# TOWN OF NEWBURGH PLANNING BOARD TECHNICAL REVIEW COMMENTS

PROJECT NAME: MATRIX 1-84 DISTRIBUTION CENTER- SITE PLAN

PROJECT NO.: 22-29

REVIEW DATE: 15 OCTOBER 2023

# TYPICAL PARKING SPACE DETAIL SCALE: N.T.S.

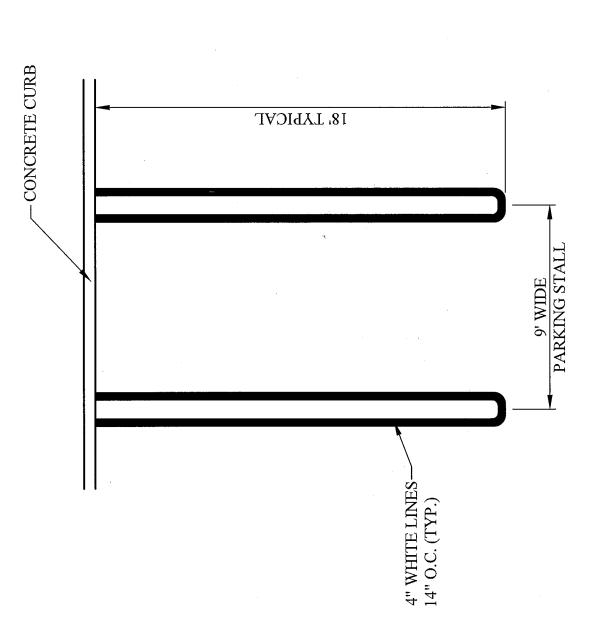
- 10. Parking lot striping should be per Town of Newburgh Standards with double stripe. Typical Detail attached.
- 11. Orange County Health Department approval for the water main extension is required.

Drawing No. **CS002**

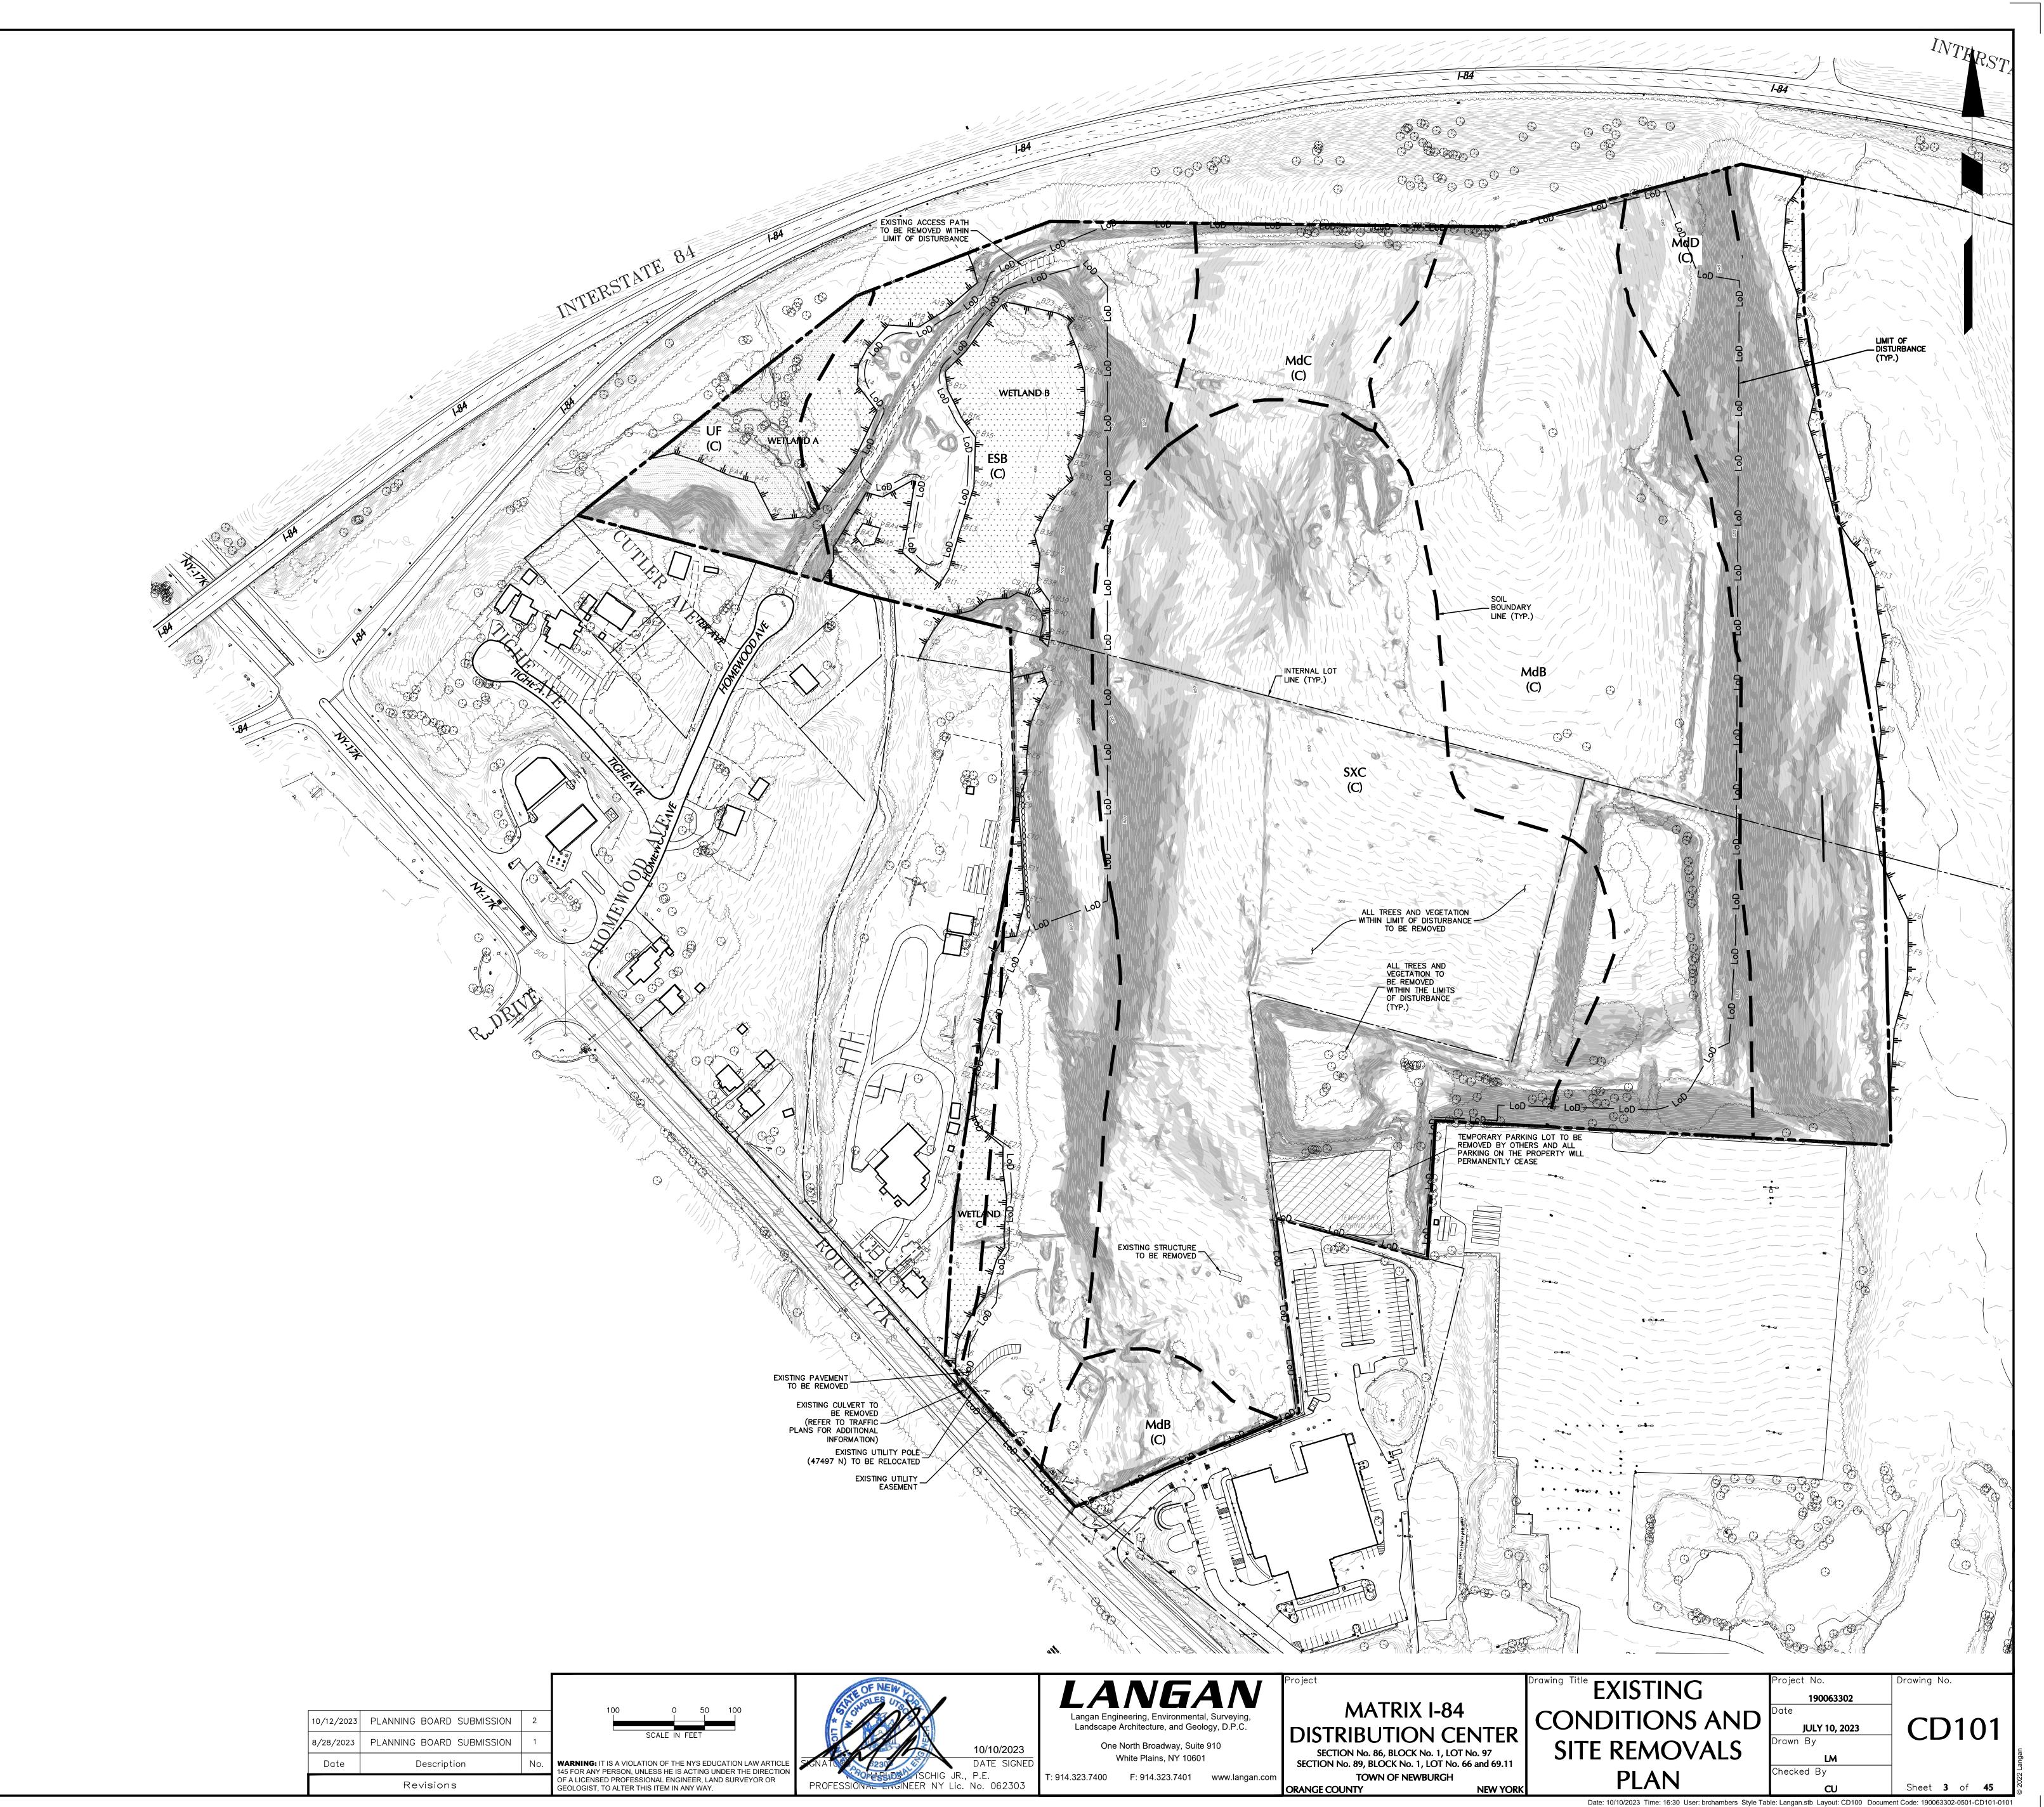
Comment 4. Additional notes regarding replacement of washed-out soil, not just mulch, must be added to the plans. It is imperative to have a strategy in place for washed out soils to avoid erosion in the landscape and to ensure plants have sufficient depth of soil needed to thrive.

Instances of washed out soil shall be addressed as part of the erosion and sediment control measures on site. Additional notes have been added to confirm that washed soil is addressed in the Stabilization of Disturbed Surfaces Notes on Sheet CS002.

**DRAINAGE DETAILS** (1 OF 2)

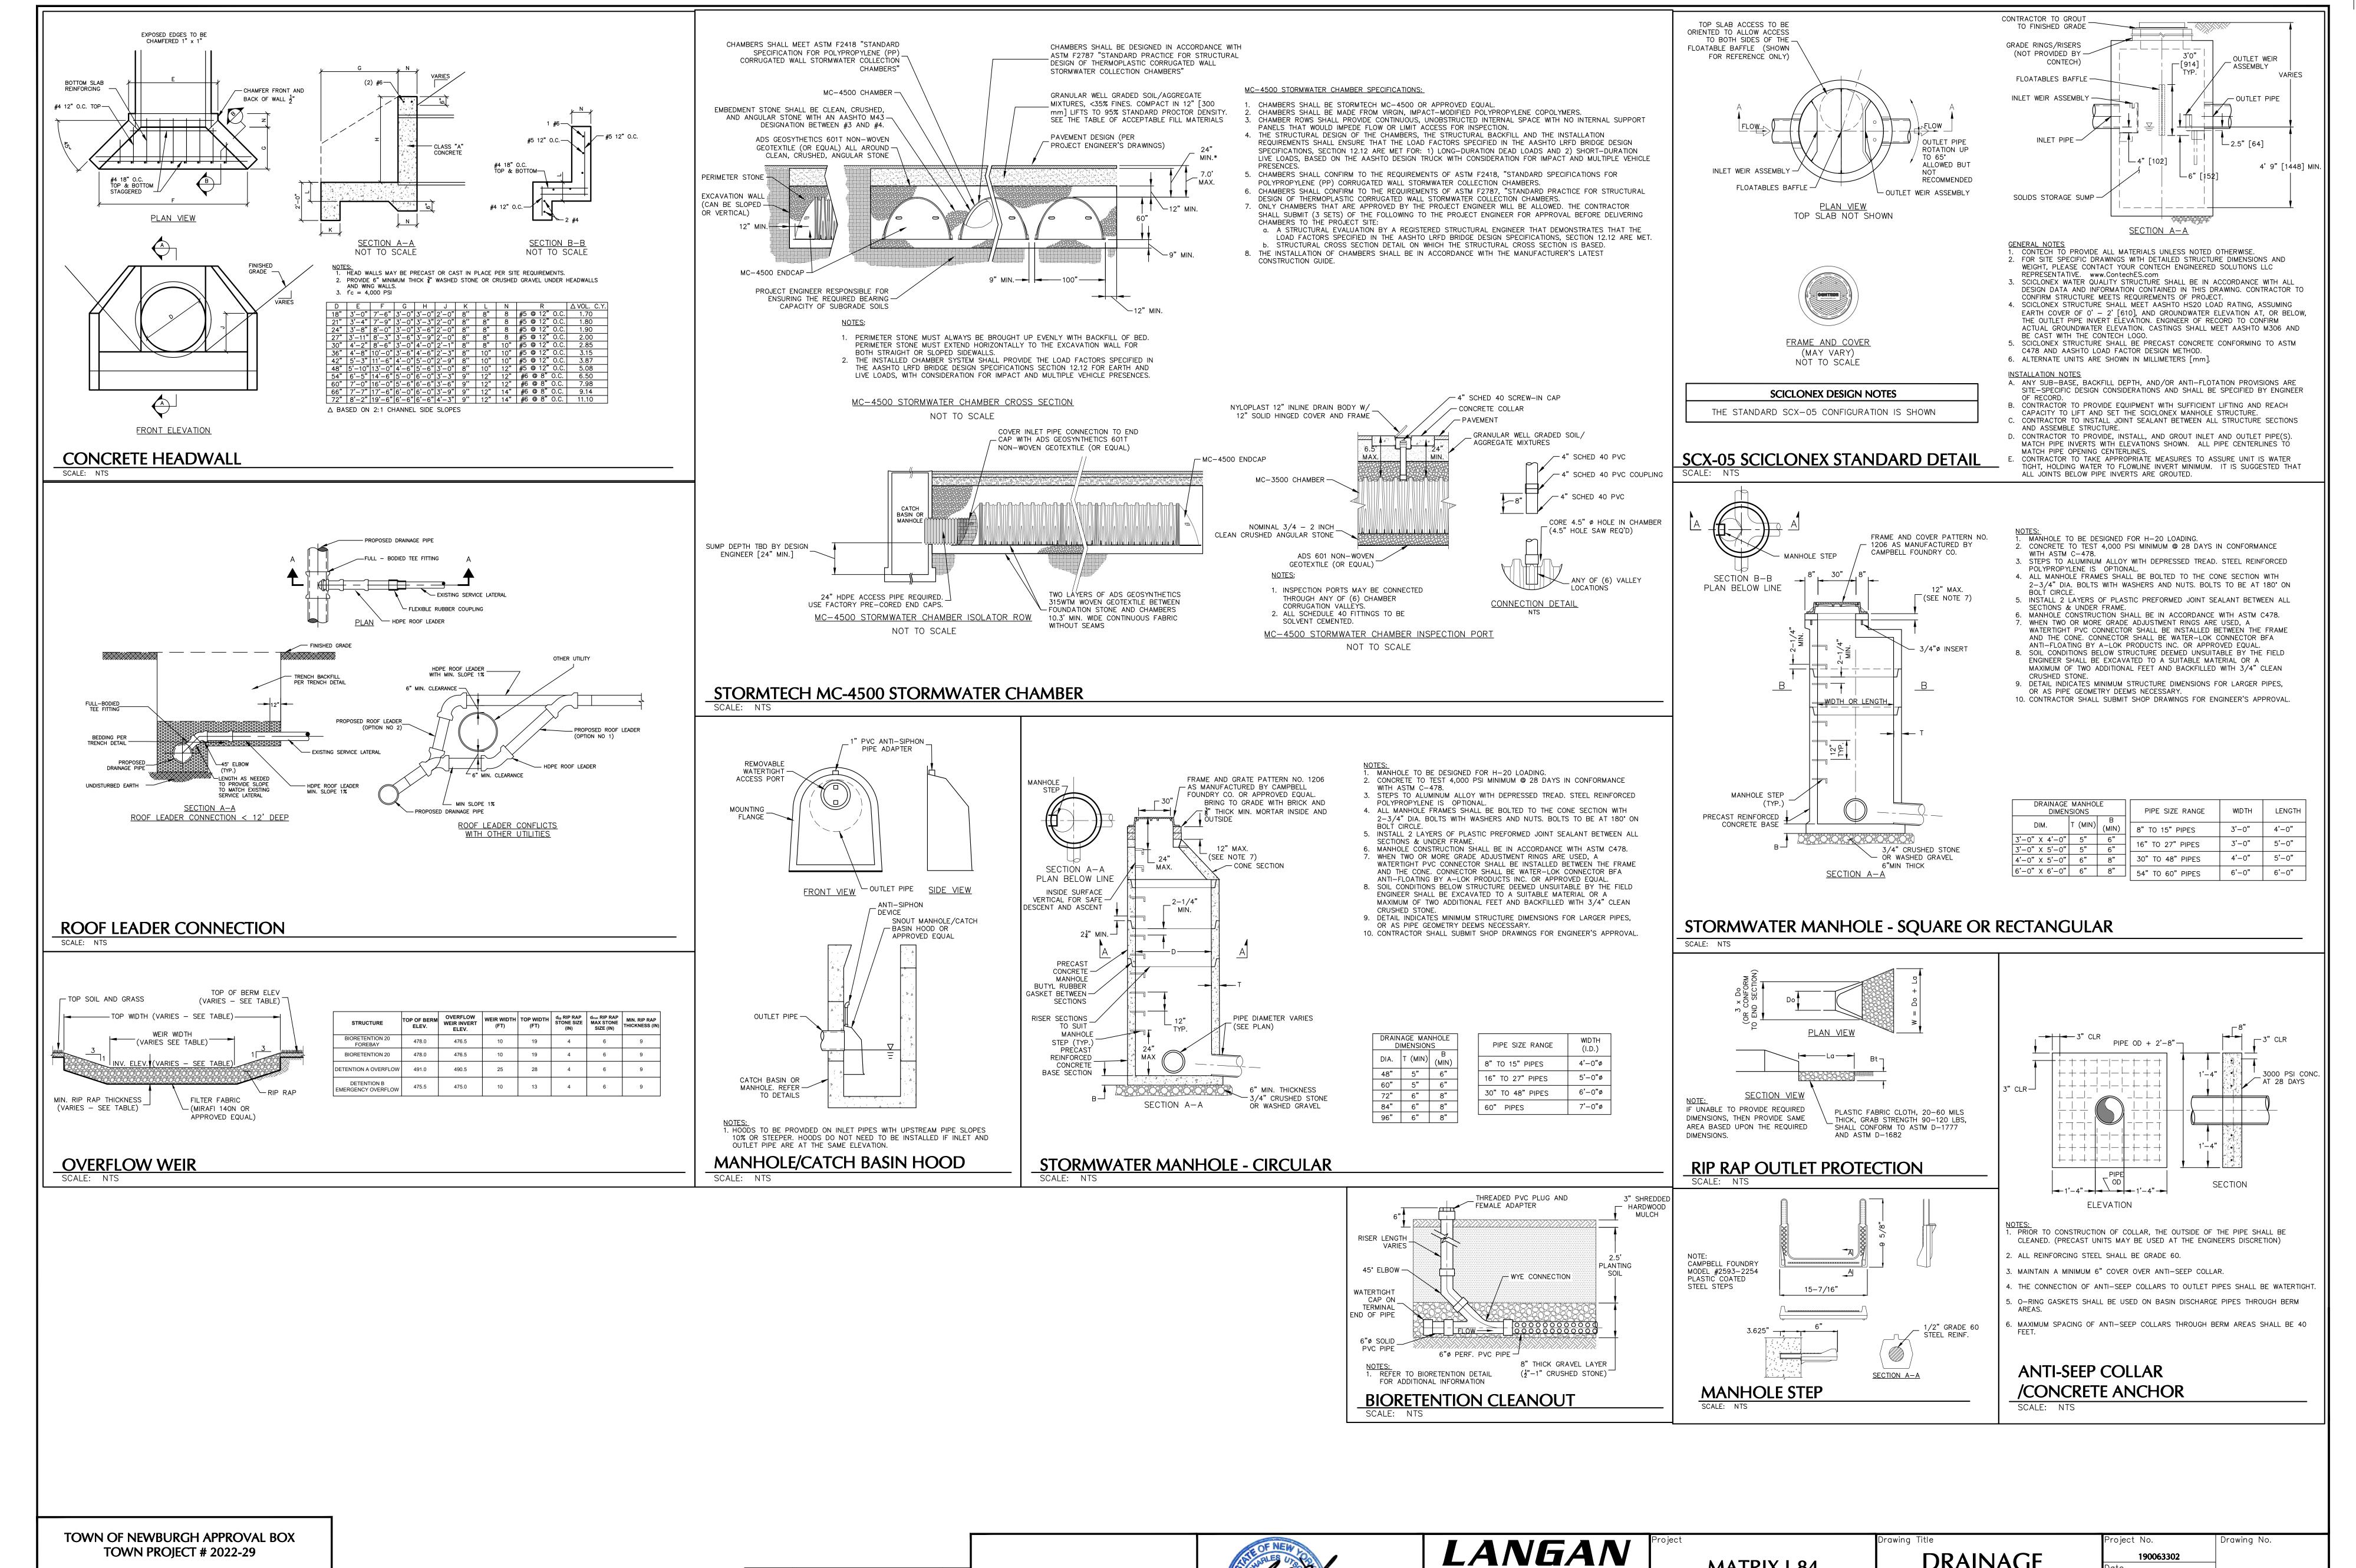
Updated details for Bioretention Basins were not included in this submission. Provide details for the basins which reflect previously issued comment 7.

The bioretention detail on Drawing CS505 has been revised.
